Re: North Bala Falls Small Hydro Project – Response to Enquiries from STBF

Further to our meeting of May 1st, we have prepared the following response to the two documents you have received from SaveTheBalaFalls and its members / supporters listed below:

Purple represents the "building"
 Blue represents "water conveyance" structure.
 Green represents the removal roof hatch.
 Brown is the driveway

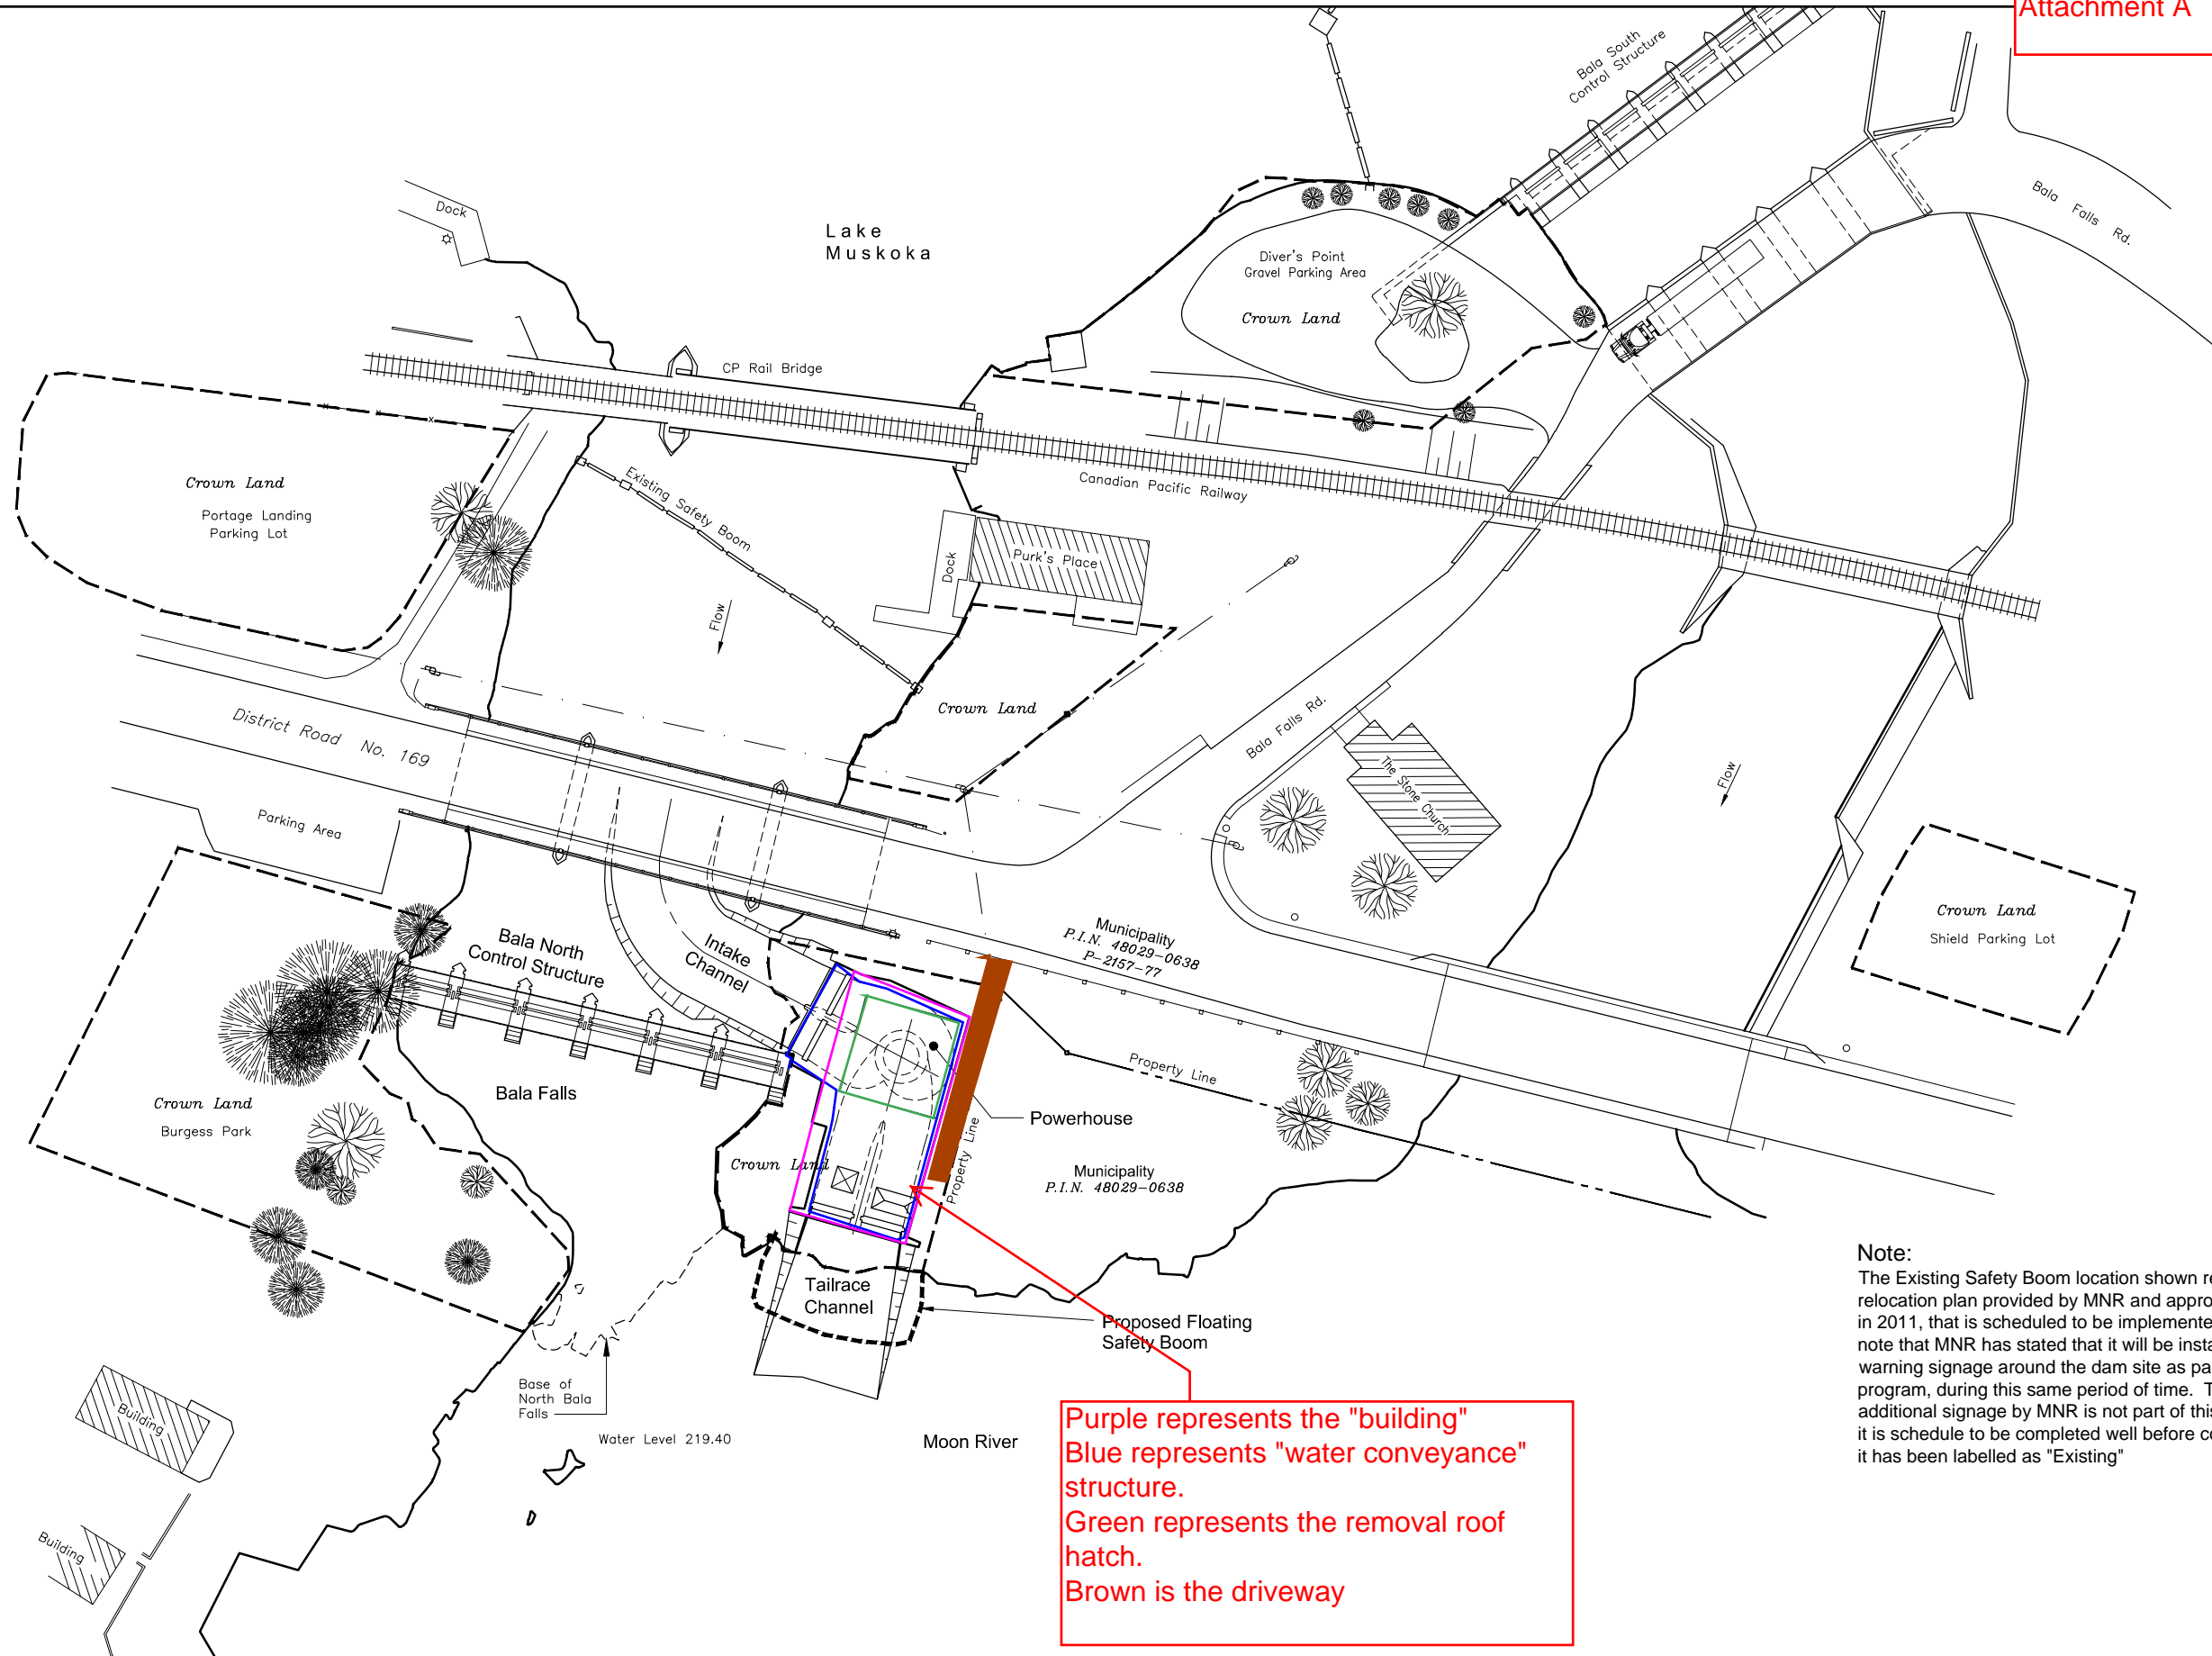
- g) The proponent committed that the building footprint presented in their 2012 Addendum would be the “largest building size required” and “this size may indeed be reduced following detailed design prior to construction”. They also stated they would provide tree plantings. However, they proponent has actually increased the footprint to be 48% larger still, and would not provide any tree plantings.*

- iv. *Roof height increase to 20'-30' above Highway 169, exacerbated by use of vertical turbine. 2012 Addm pdf page 29, s4.6.1, 6.2.2 and 6.2.3 committed to a height level at or below Muskoka Road 169.*

We have attached sketches to this letter from both the 2012 Addendum and the most recent permit application drawings (provided to the MOECC and other approval agencies) to represent any changes in design since the 2012 Addendum (Attachments A through D). Highlighting and notes have been added to describe some of the changes and to provide more detail. As stated above, no dimensions have been provided on either sketch as they haven’t been fully designed and are still considered conceptual. You will see that while the overall width of the footprint of the “structure” has increased somewhat, the “building” width is similar in both plans. The length of the “structure” is similar in both plans, but the length of the “building” has actually be reduced from that shown in the 2012 Addendum, as it no longer extends all the way to the water’s edge.

For greater clarity, the water conveyance structure is a low profile concrete section, located for the most part underground. The top of it will be a concrete, open deck for maintenance access. The deck will be at approximately grade level for the upstream half of the structure then step down to approximately 2.0 m above the high water level at the water’s edge. The building will rise above the water conveyance structure at the upstream end.

Therefore, since the building footprint was never fully defined in the 2012 Addendum and the sketches indicate no significant change in overall footprint or height, this is not considered to be a change to the project. It is anticipated that since the building will no longer extend all the way to the water’s edge there will be a positive environmental effect from an aesthetics point of view.

Figure 2.1

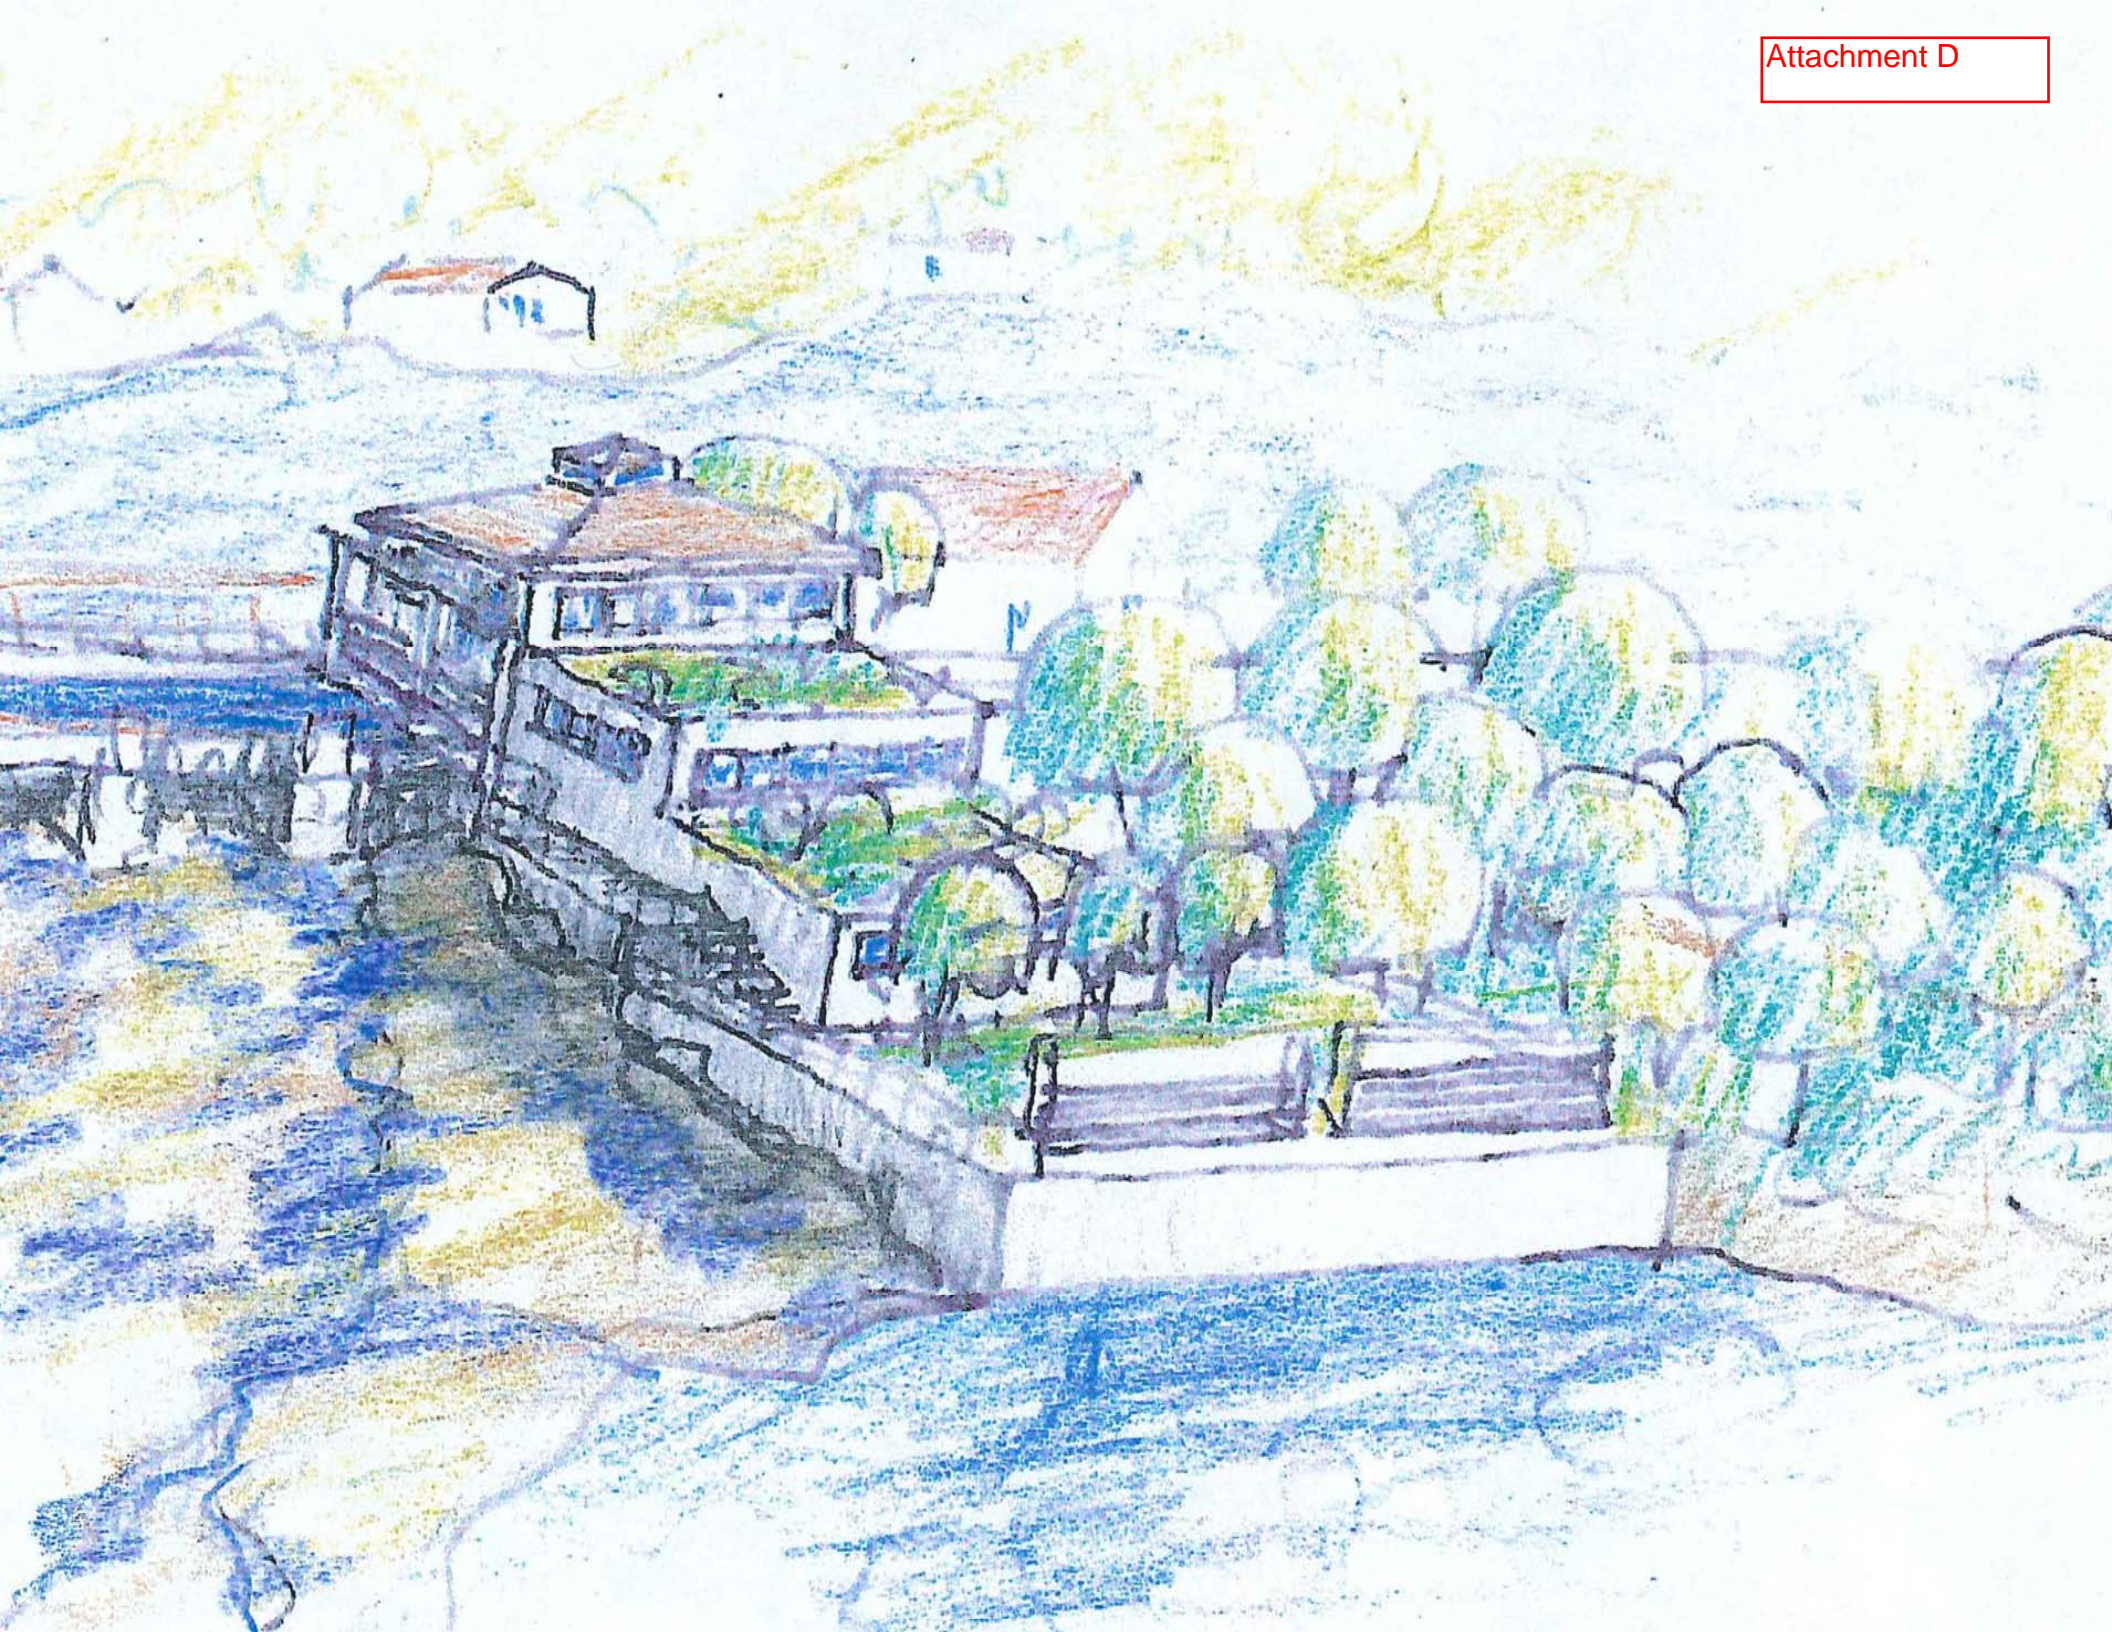
- i. *48% larger plant footprint. Increased from 400 to some 600 square meters since 2012 Addm. – This increase to occupy 92% of the site has not been seen, recognized, reviewed or approved by any ministry.*
